INTERDISCIPLINARY SCIENCE BUILDING

MOCK-UP
ELEVATION AND PLANS

RE: Metal panel mock-up shop drawings Rev 2

RE: Metal panel mock-up shop drawings Rev 1

5
D1 SECT. DTL. AT BASE TERMINATION
SCALE: FULL SCALE (ARCH. REF. 1A0455)

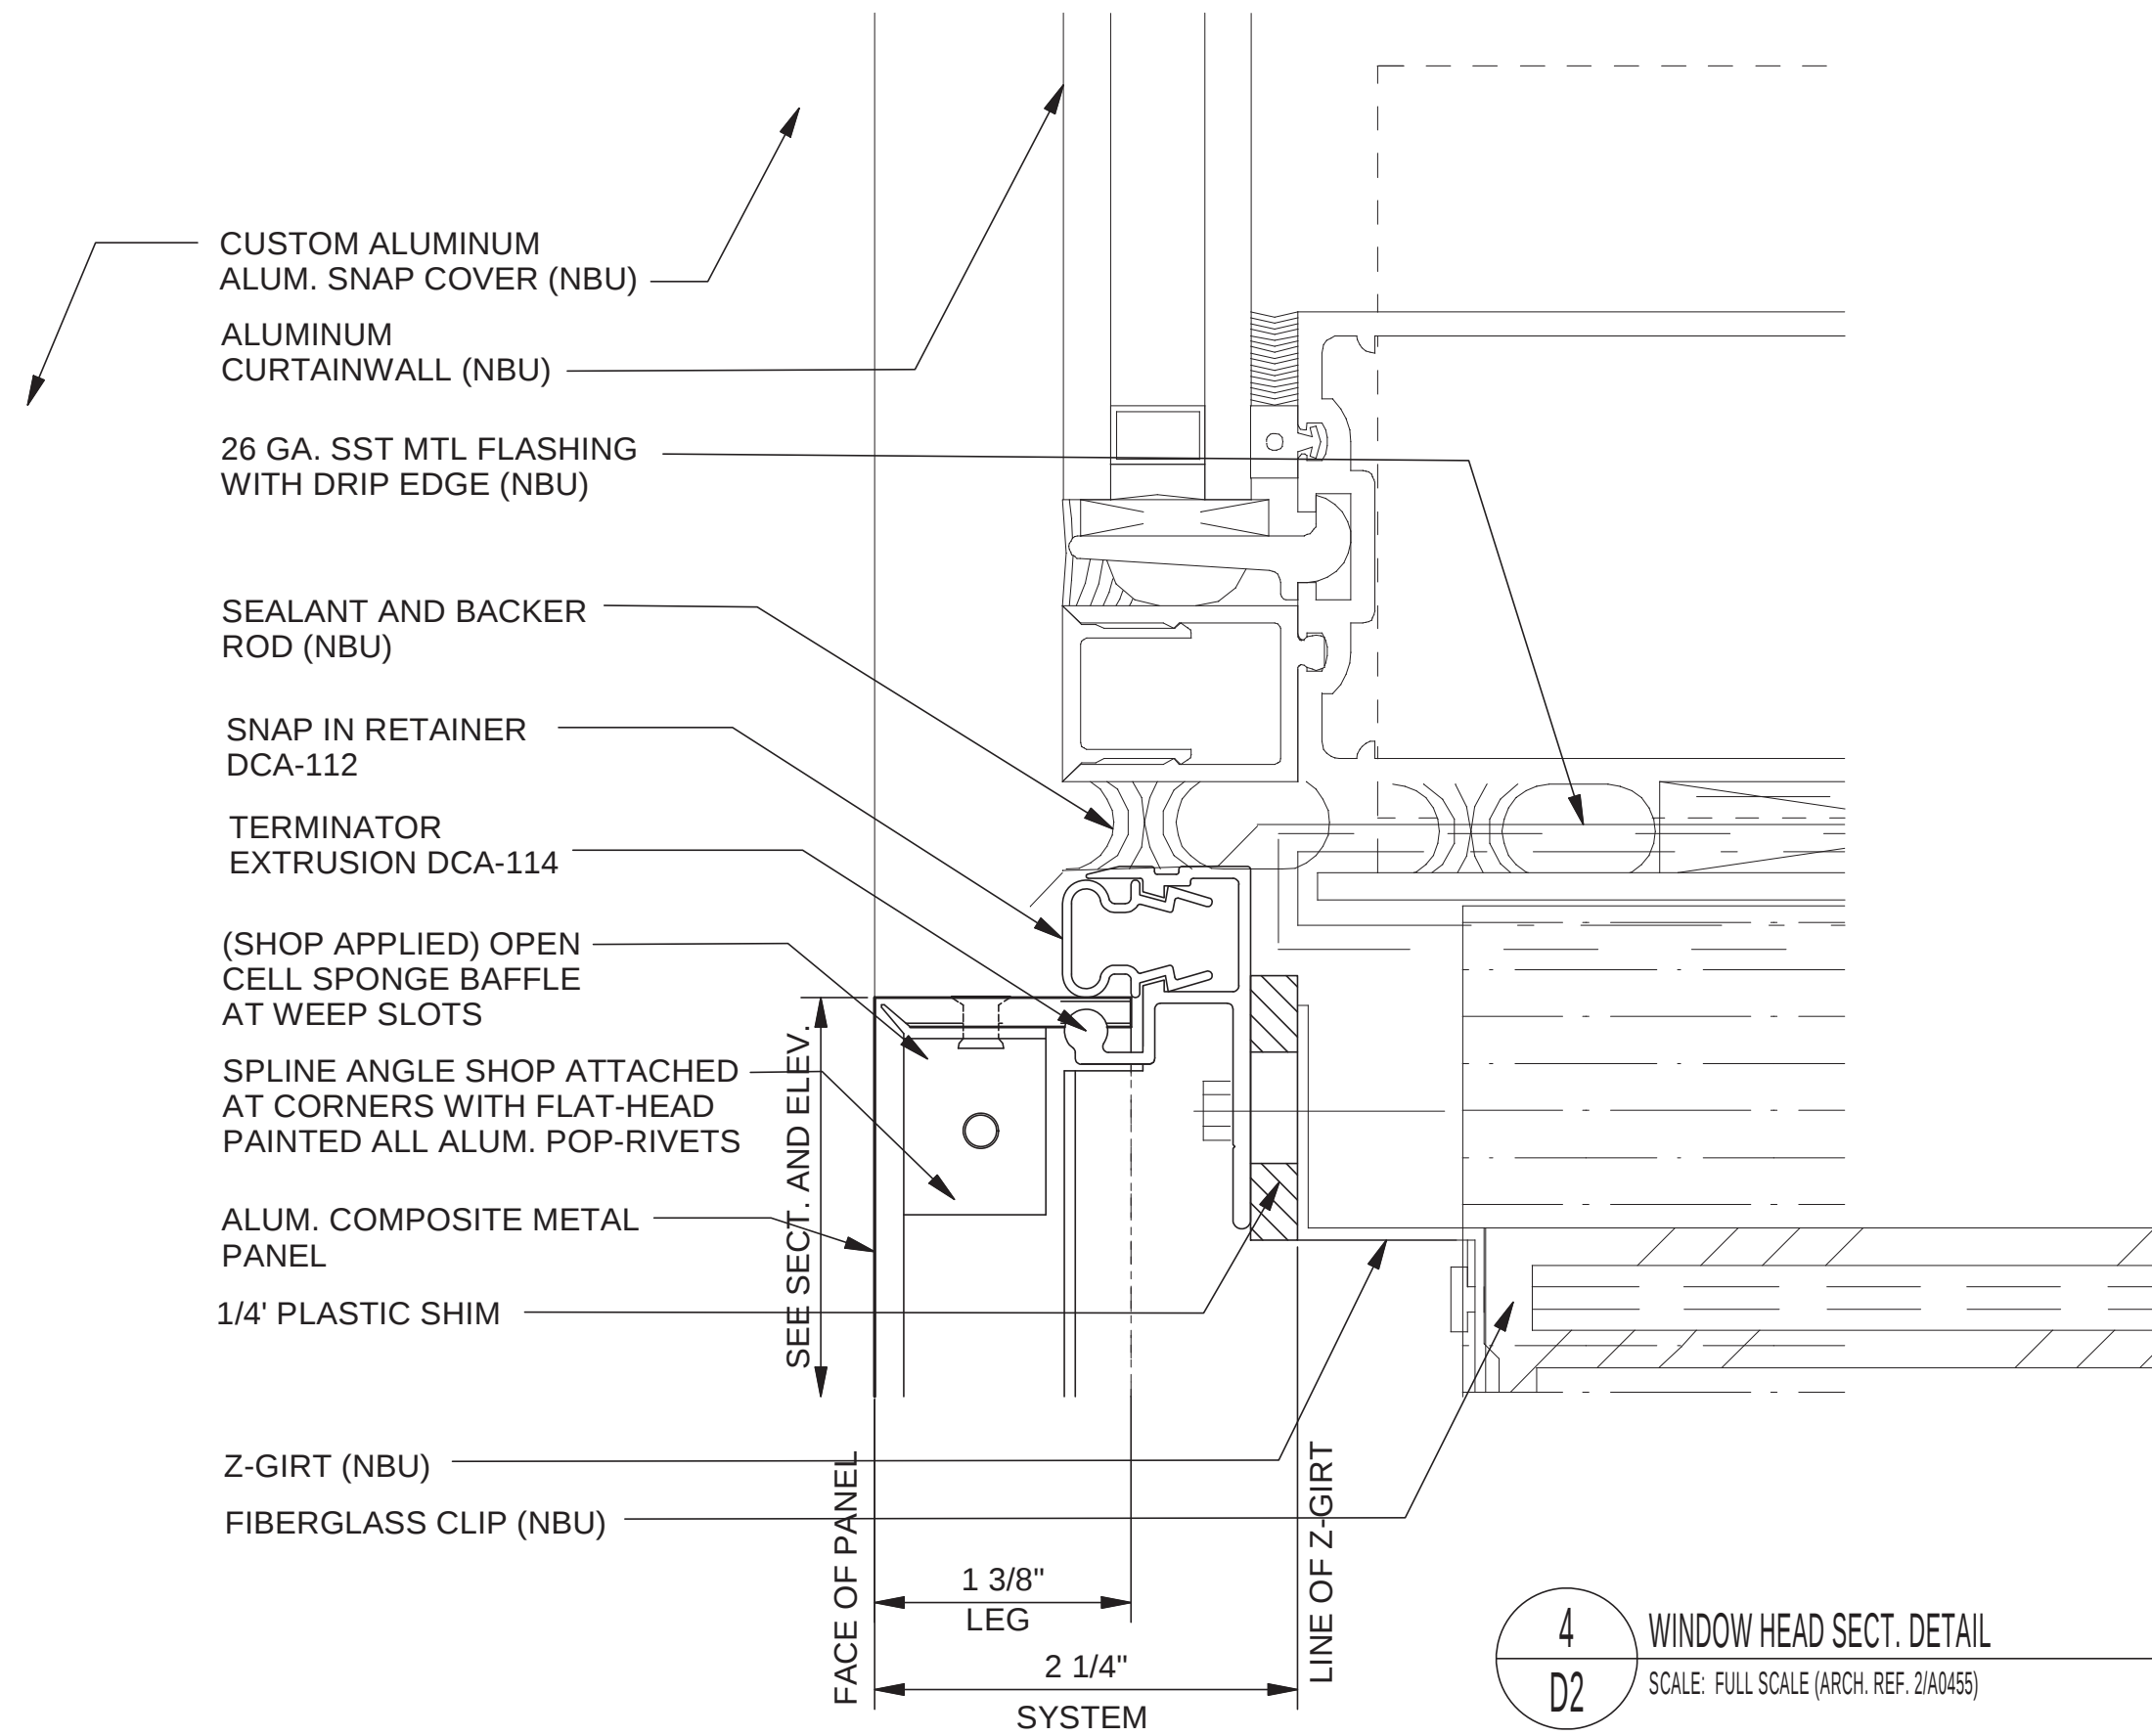
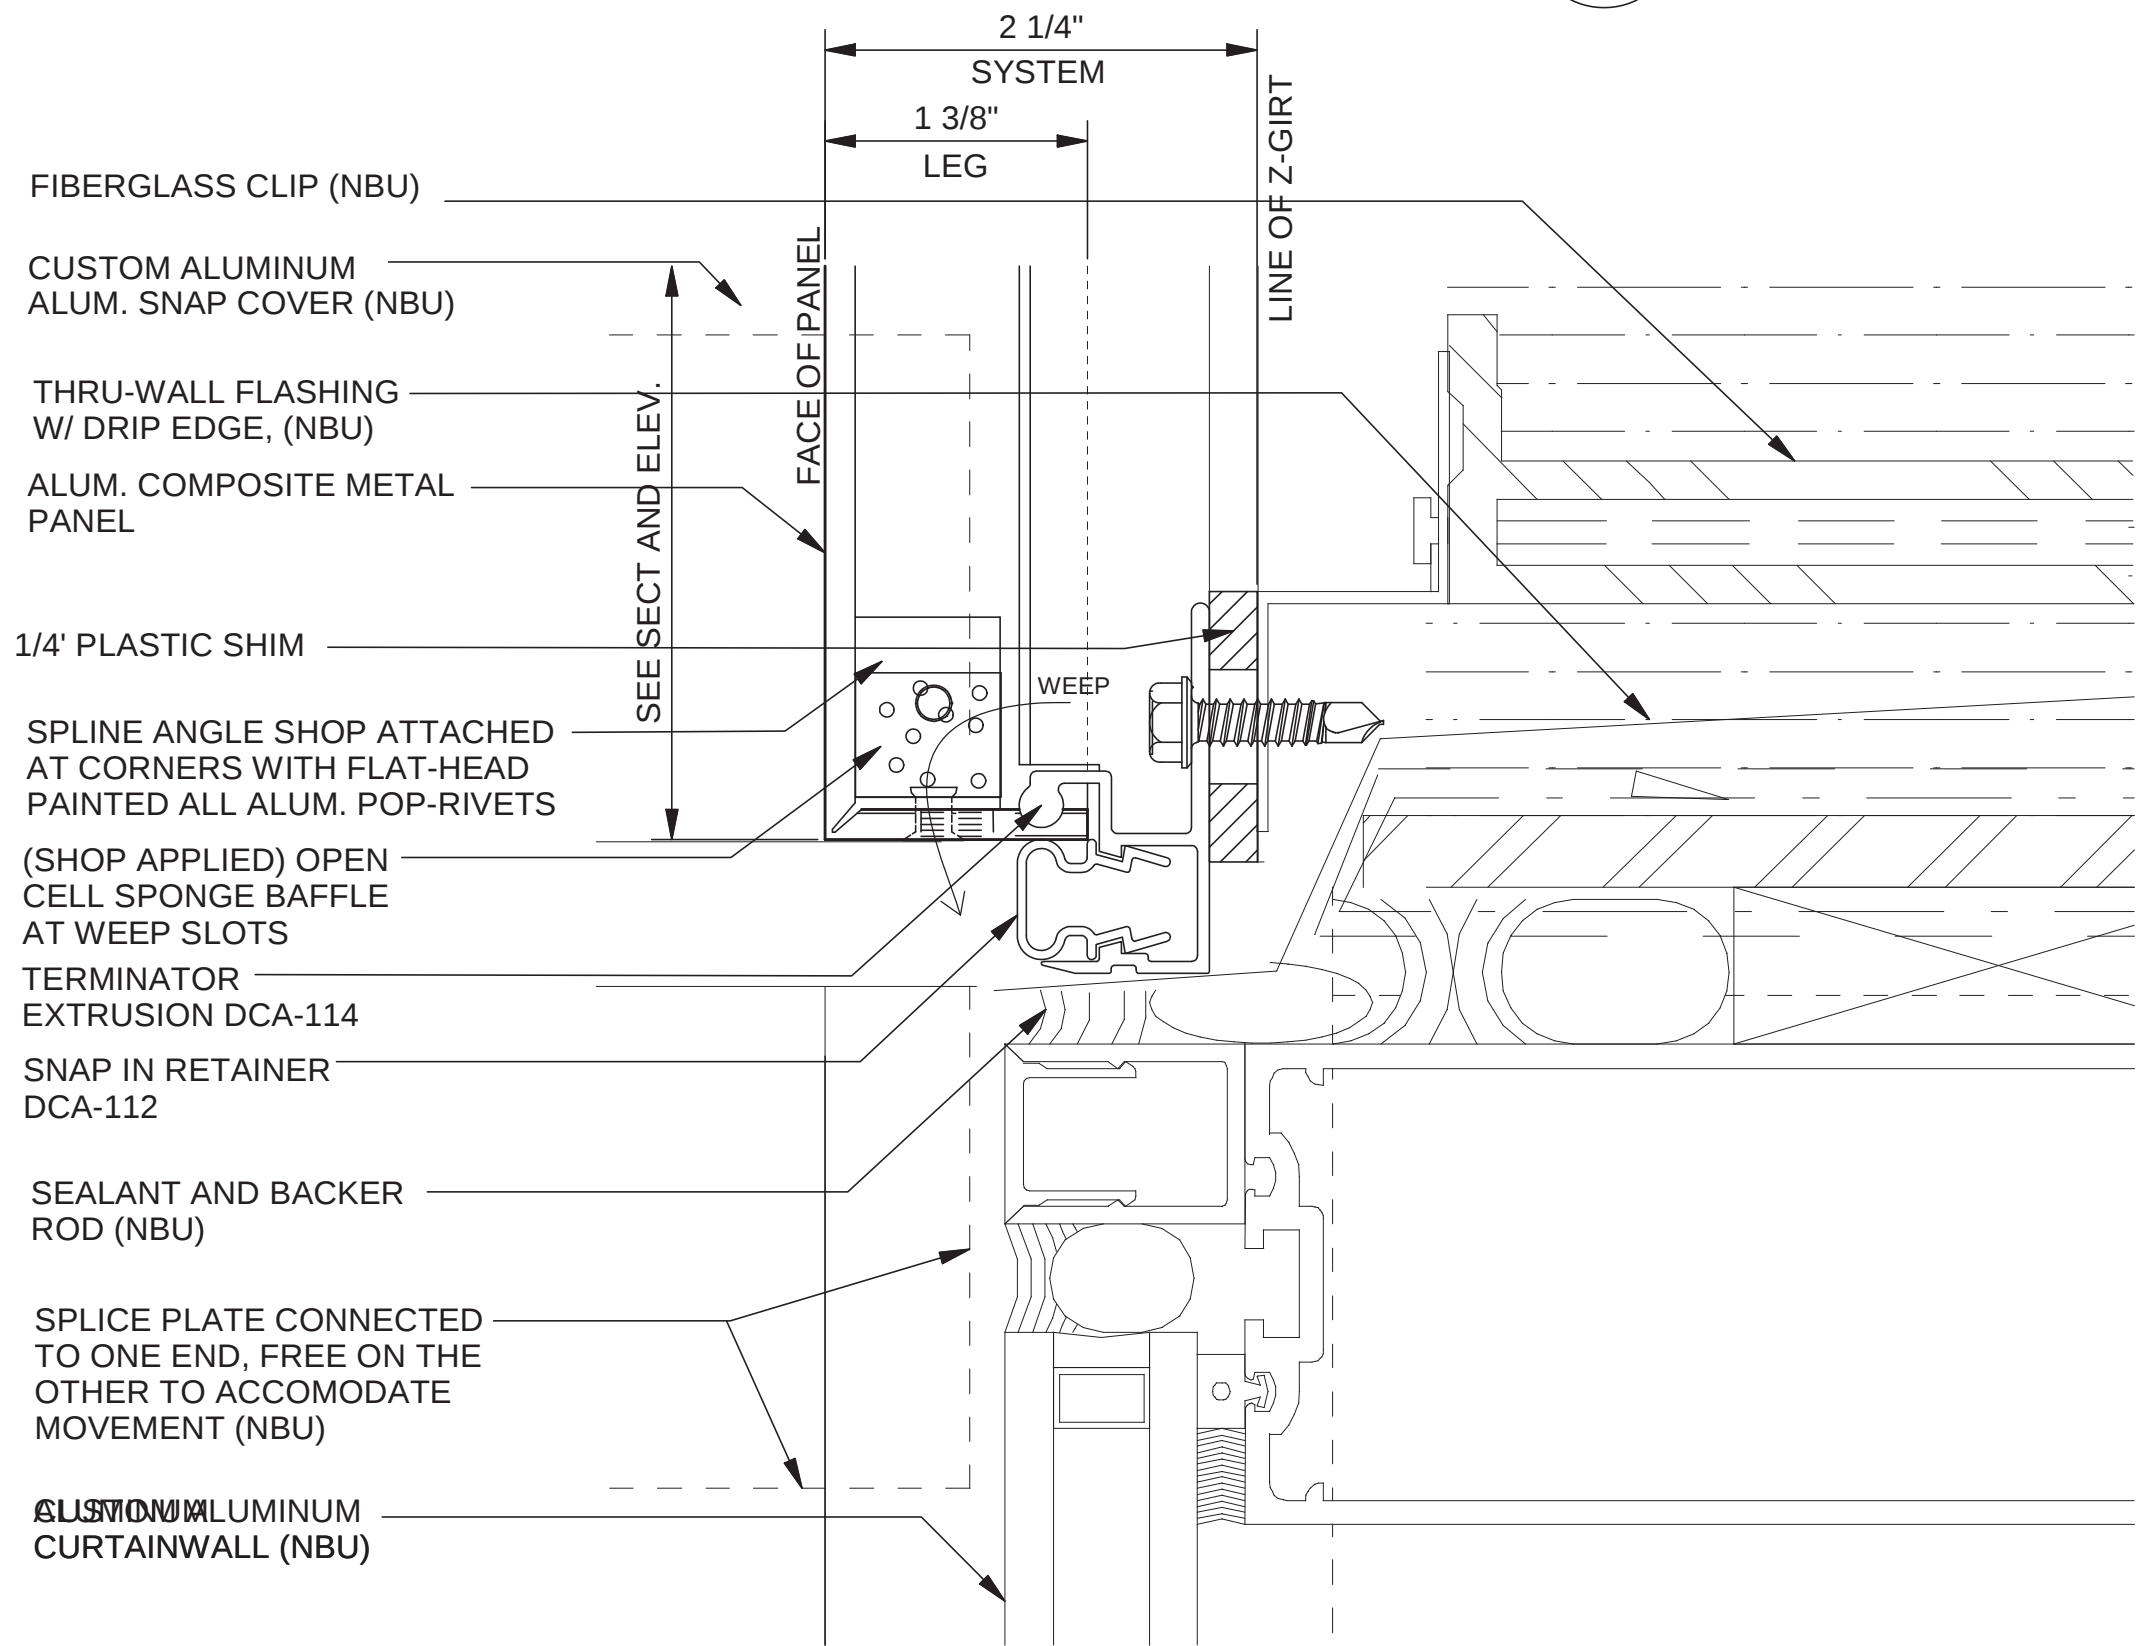
ARCHITECT NOTE:
ASSUMED FRAMING MOVEMENT JOINT (N.B.U.)
- NO DETAIL TO REFERENCE.

Location of movement joints in alumn. composite metal panels & CFMF shall be coordinated by the General Contractor.

Location of movement joints in alumn. composite metal panels & CFMF shall be coordinated by the General Contractor.
